STATE OF VERMONT
AGENCY OF TRANSPORTATION

RECORD PLANS

PROPOSED IMPROVEMENT
BRIDGE PROJECT
TOWN OF ST. JOHNSBURY
COUNTY OF CALEDONIA
VT ROUTE 2B (URBAN MINOR ARTERIAL) BRIDGE NO. 6

PROJECT NAME : ST. JOHNSBURY
PROJECT NUMBER : BF 7000 (20)

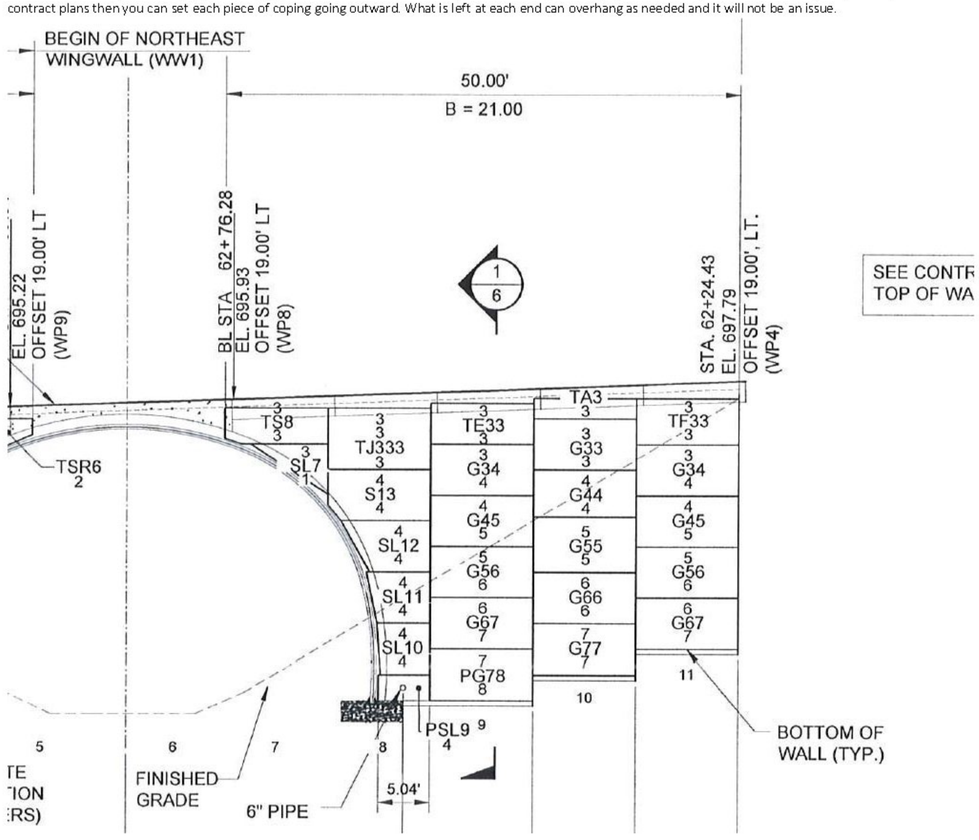
Please see attached e-mail from BiG R speaking to the length of coping vs the length of wall

If you look at our drawings we show the coping running past the end of the wall at WP4. Because the grade will be up to the bottom of the coping at this point, I so no issue with having a little coping overhanging the wall at this location. Thus you take what you have proposed and they install the cast in place portion per the contract plans then you can set each piece of coping going outward. What is left at each end can overhang as needed and it will not be an issue.

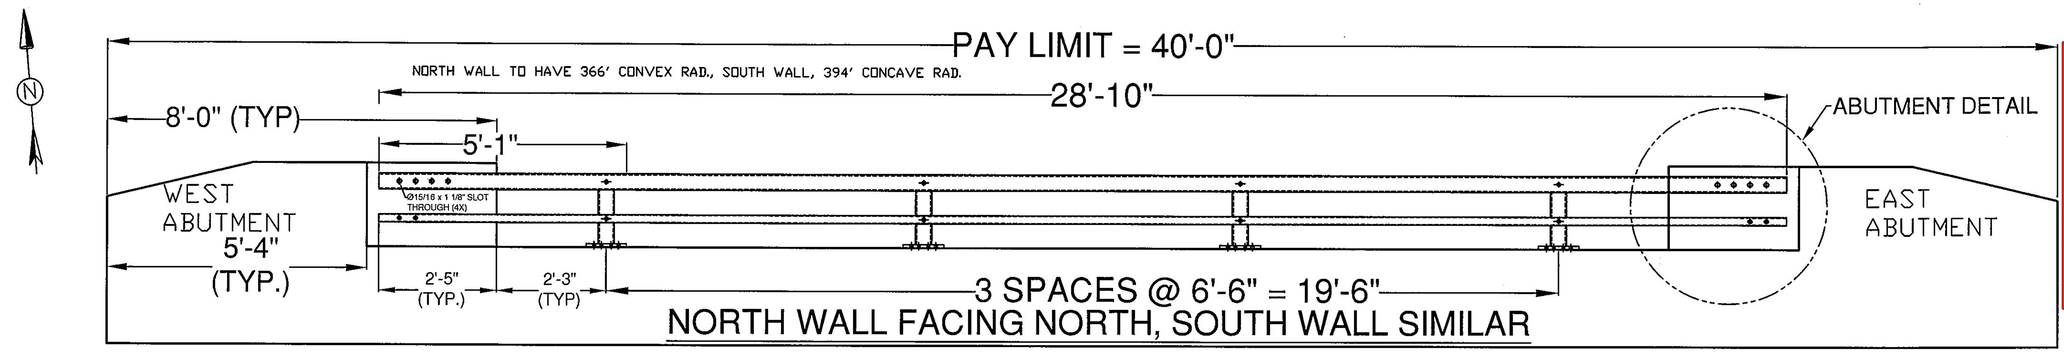
Also: Sheet 49 (of 70), Railing angle shows 3/8" / ft for top rail & 1/8" / ft. for bottom rail. I come up with 1/4" / ft. for the top rail and 1/16" / ft for the bottom rail -see accompanying sheet (This brings to question the 3'-0" height at the wall)

Sheet 50. Dimension to the center of the 7"slots, shown as 2 3/4", should be 2 11/16".

Sheet 51. This is calling for a bent splice tube. The other jobs utilize a straight splice tube (which works fine) and they have a greater angle due to their shorter length. A straight splice tube will work for this application and was what was quoted.

ITEM 17 - N/S

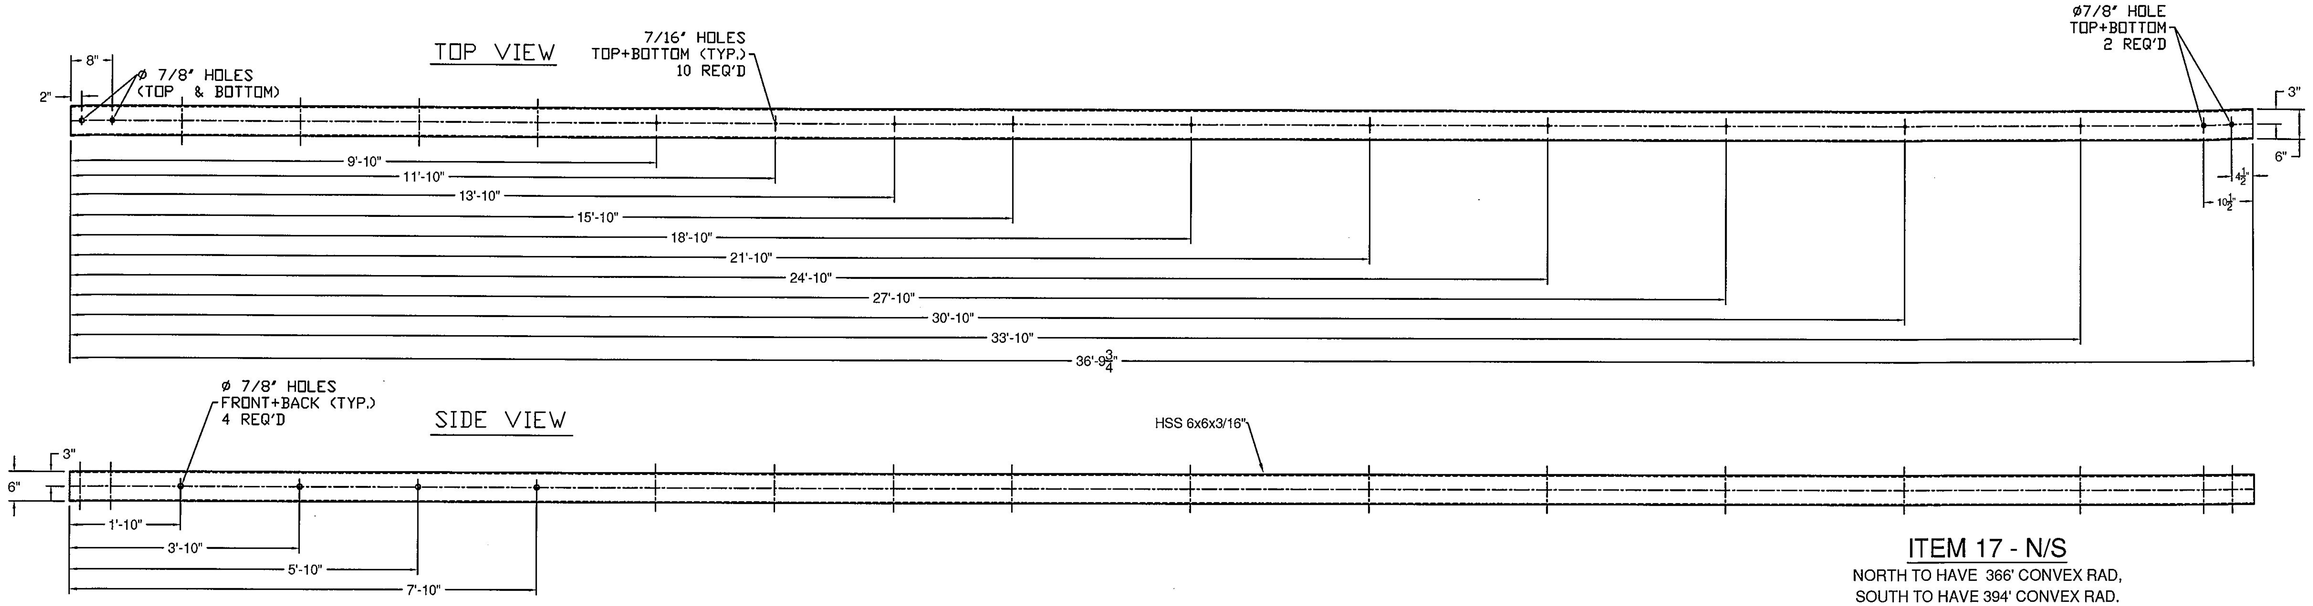
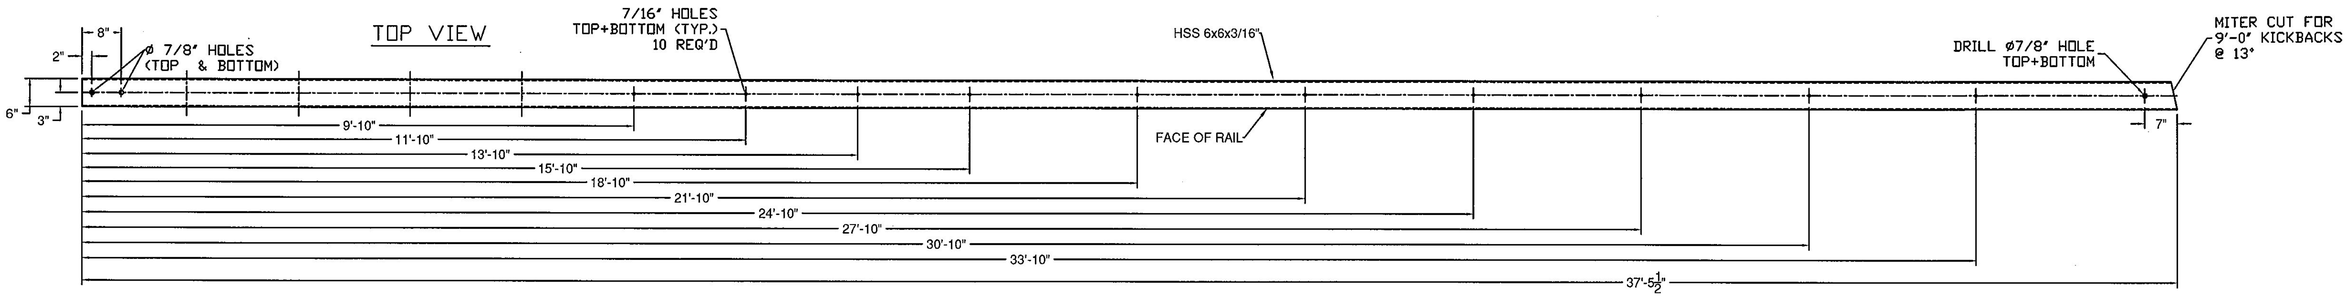
NORTH TO HAVE 366' CONVEX RAD,
SOUTH TO HAVE 394' CONVEX RAD.
